SERVICE BULLETINNO. 3aDATE JUNE 87CFM METAL-FAX LTD CONSIDERSCOMPLIANCE - ~~Mandatory~~/Recommended/~~Optional~~  
(delete which is not applicable)

<u>SUBJECT</u>	AIR GUIDE - COOLING SHROUD	
<u>MODELS AFFECTED</u>	ALL SHADOW AIRCRAFT FITTED WITH ROTAX 447 ENGINE	
<u>SERIES NOS. AFFECTED</u>	B and B-D	
<u>COMPLIANCE TIME</u>	FIT AS SOON AS POSSIBLE	
<u>PURPOSE</u>	TO REDUCE THE TEMPERATURE DIFFERENTIAL BETWEEN THE FRONT AND REAR CYLINDERS.	
<u>INSTRUCTIONS</u>	STUDY DRAWING PROVIDED.  ATTACH AIR GUIDE TO INSIDE OF UPPER COWLING WITH 1/8" DIA. POP RIVETS.	
<u>MATERIAL REQUIRED</u>	ENCLOSED:	(1) AIR GUIDE (3) 1/8" POP RIVETS
<u>AVAILABILITY OF PARTS</u>	EX. STOCK	
<u>EFFECTIVITY DATE</u>	23rd JUNE 1987	
<u>SUMMARY</u>	CFM METAL-FAX REPORTED TO ROTAX THAT THE FRONT CYLINDER HEAD TEMPERATURE EXCEEDED THEIR STATED LIMITS. ROTAX SIMULATED TRIALS WITH '447' AS FITTED TO THE SHADOW AIRCRAFT. THEY REPORTED THAT THERE IS NO INSTALLATION PROBLEM IN RESPECT OF THE REAR FUSELAGE WALL SHIELDING.	
<u>NOTES</u>	ROTAX ADVISE THE FITMENT OF THIS AIR GUIDE TO REDUCE THE TEMPERATURE DIFFERENTIAL BETWEEN THE CYLINDER TO WITHIN LIMITS.  PREVIOUSLY THE FRONT CYLINDER (MAG. END) WAS READING HIGHER THAN TH

DRAWING No. E119

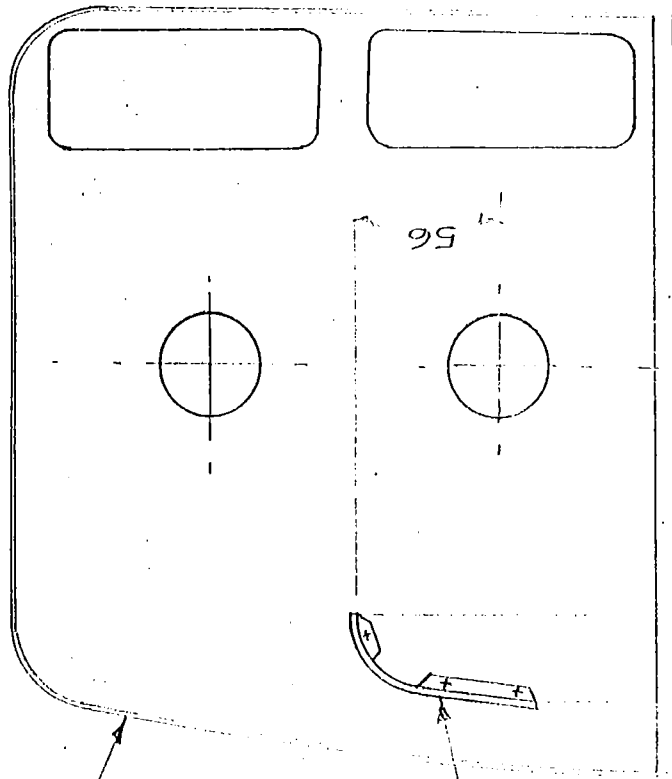
AIR DEFLECTOR  
(E118) AFFIX WITH  
(3) 1/8" DIA FOR RIVETS
